# Tailormade Field House

PL2023-162-Preliminary Development Plan

Lee's Summit Planning Commission— September 14, 2023

# Floor Plan

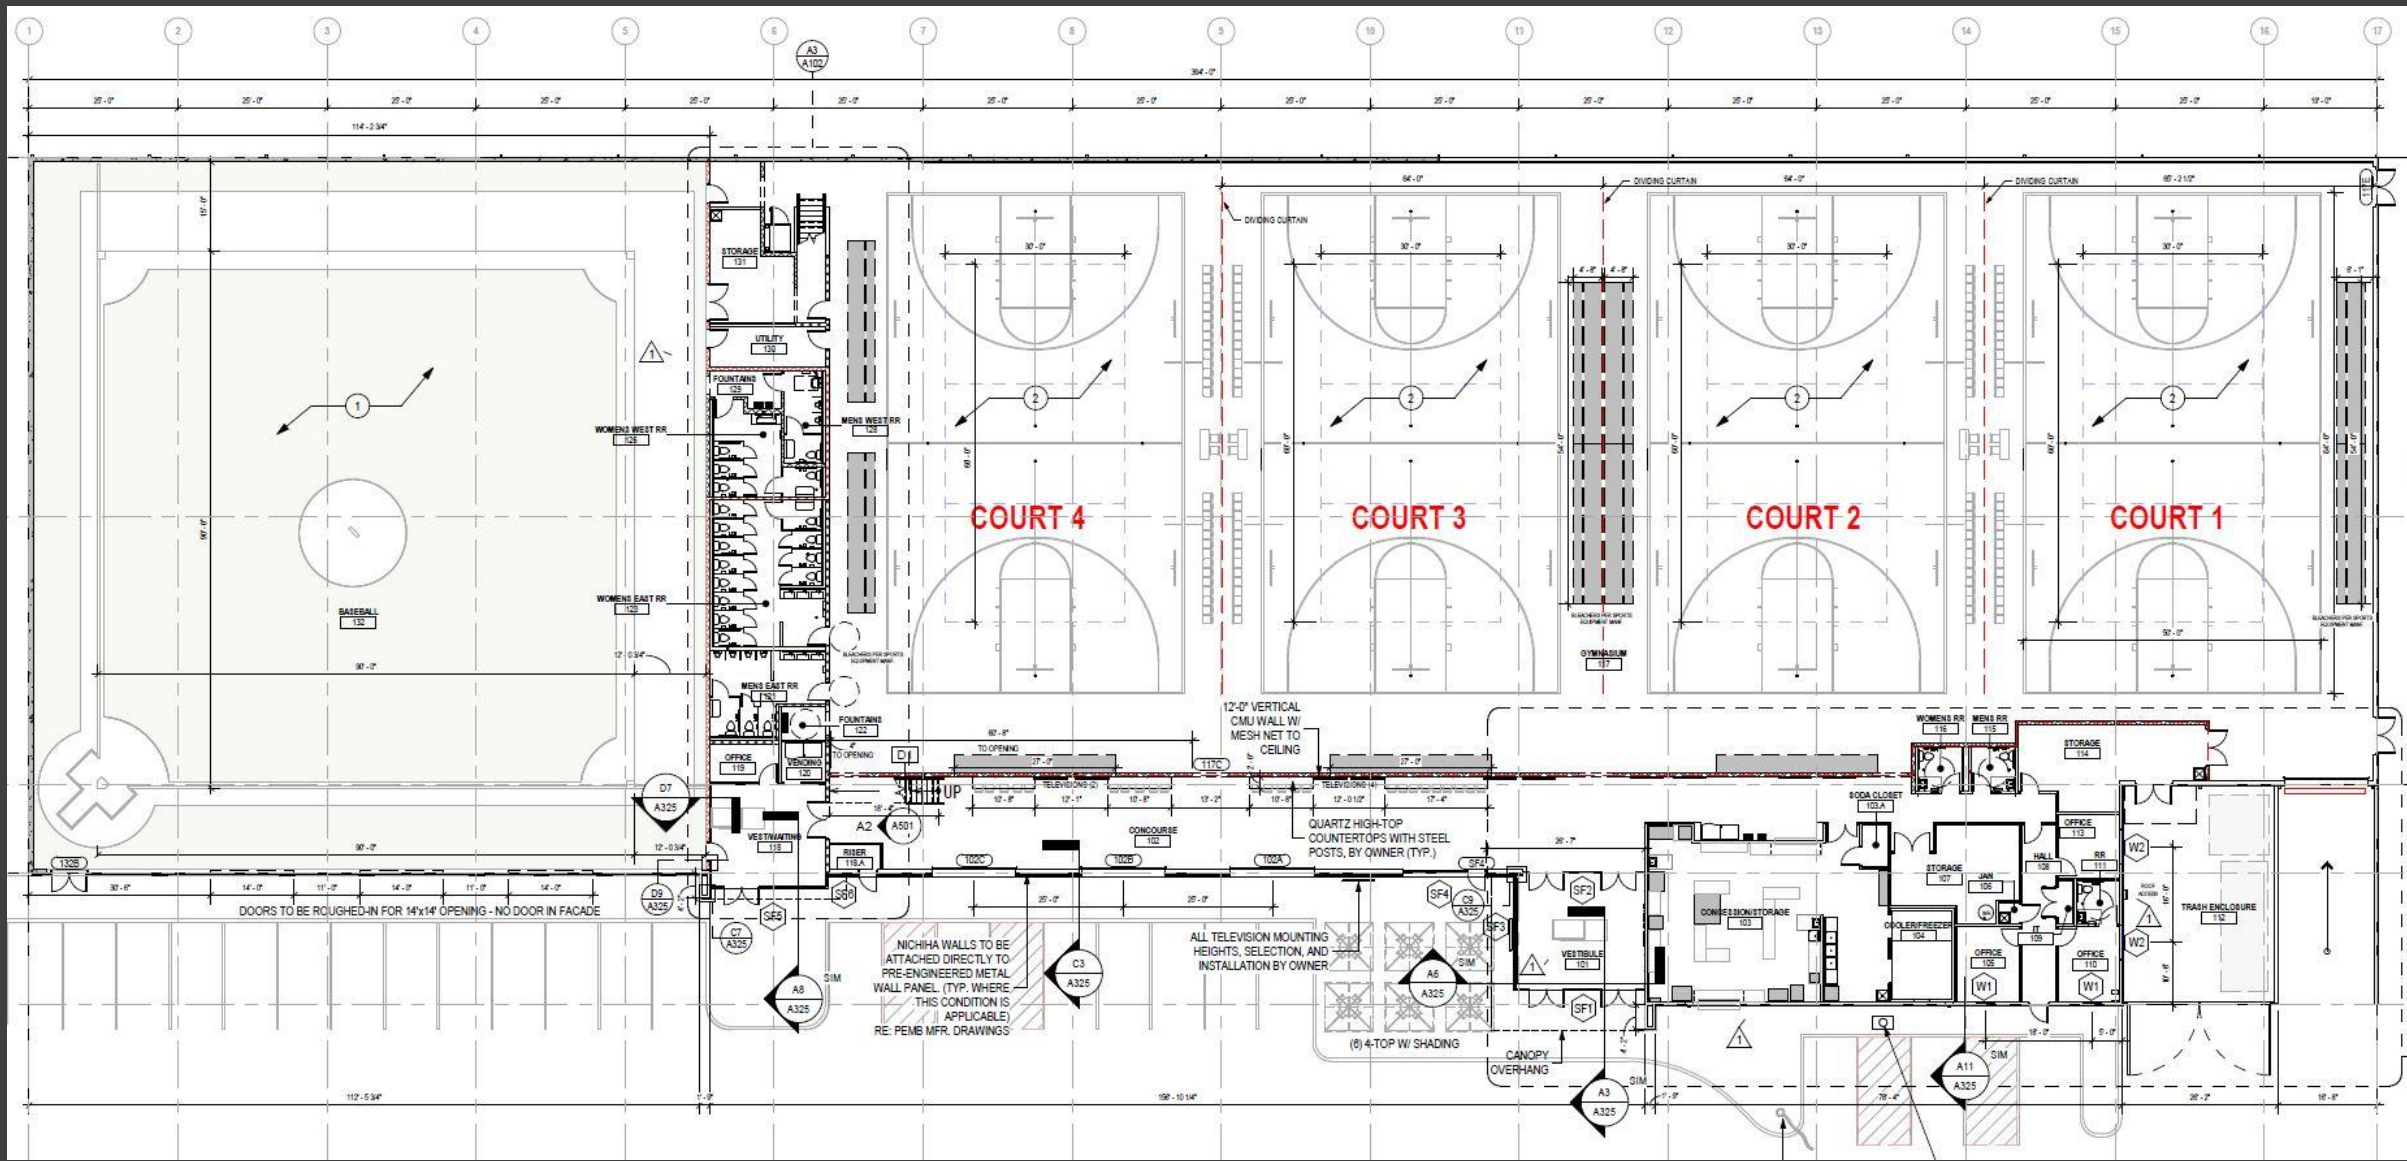
## Modification Requests

The applicant has requested a modification to UDO Sec. 8.180 - Architectural Characteristics.

**Required** – All roof-mounted equipment shall be screened entirely from view by using parapet walls at the same height as the mechanical units.

**Proposed** – The applicant has proposed to utilize bolt on screening in the place of a parapet wall.

The applicant has requested a modification to UDO Sec. 8.620 - Parking lot design.

**Required** – Head-in parking from any public right-of-way or private street shall not be permitted.

**Proposed** – The applicant has requested the use of head-in parking along the private street servicing the proposed project.

The applicant has requested the use of architectural metal panels. The UDO restricts building materials to masonry, concrete, stucco, and glass in the PI zoning district. Metal is limited to an incidental role or as other architectural metal siding as approved by the Planning Commission and/or City Council.

**Recommended** – With larger building, constructing a parapet wall that encompasses the entire perimeter of the proposed roof line is excessive and not practical. The proposed screening system is opaque and provides adequate screening of the mechanical units while meeting the intent of the UDO requirement. This same modification has been granted in the past such as the Coleman Equipment development at 4101 NE Lakewood Way (PL2017-097). For this reason, staff believes the modification is reasonable and supports the request.

**Recommendation** – Access to the two uses (Field house and contractor) are through a single private street. The two uses will be operated on opposite schedules. The contractor use is primarily Monday - Friday, 8 to 5 with the proposed Field House being operated primarily on evenings and weekends. This separation of uses makes the private street serving the site function similar to a parking lot entrance. The proposed additional parking located on the private street will serve as overflow parking for the transition flow during practice changes. For these reasons, staff believes the modification is reasonable and supports the request.

As the quality of architectural metal building materials has improved, the use of said materials has increased in the areas of commercial and residential construction. This proposed material is consistent with other approved developments in the City such as churches, car dealerships and the recently approved Fire Stations.
